SERVICE INSTRUCTION

Service Instruction No. 1485B
(Supersedes Service Instruction No. 1485A)

SUBJECT: Exhaust Valve and Guide Identification Procedure

MODELS AFFECTED: All Lycoming reciprocating aircraft engines unless installed in a rotary-wing aircraft.

Figure 1.

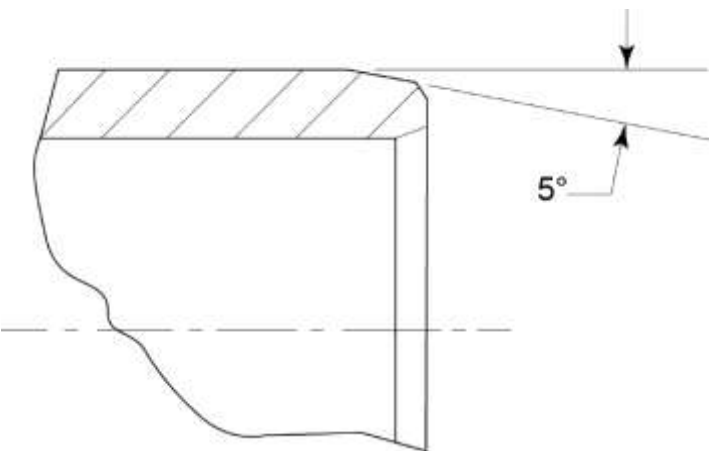
Cylinder assemblies which incorporated the improved "Hi-Chrome" exhaust valve guides when the engine was shipped from Lycoming are identifiable by the letter "C" stamped inside a circle on the boss for the drain back fitting. The individual guides made with the improved material can be identified by a 5° chamfer at the top of the guide (See Figure 1).
